# UNITED STATES PATENT AND TRADEMARK OFFICE

# Office Action Summary

09/531,735

## DETAILED ACTION

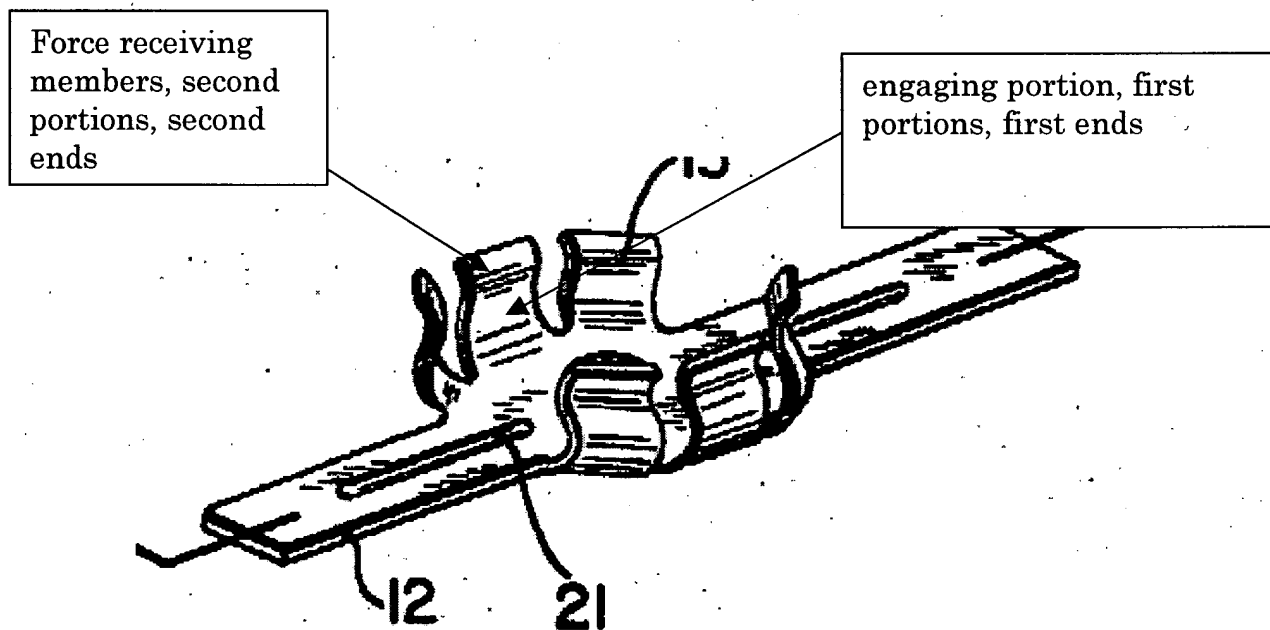
3. Claim(s) 9-22, new claims 33-35 are rejected under 35 U.S.C. 102(b) as being anticipated by Weber (part of record, 413).

As shown in the marked up figures below, Weber discloses:

engaging portions and force receiving members disposed at opposite ends (see fig above);

first and second portions disposed at opposite ends (see fig above);

first and second portions disposed at opposite ends (see fig above);

first ends including first portions and second ends including second portions disposed at opposite ends (see fig above);

first and second portions disposed at opposite ends (see fig above);
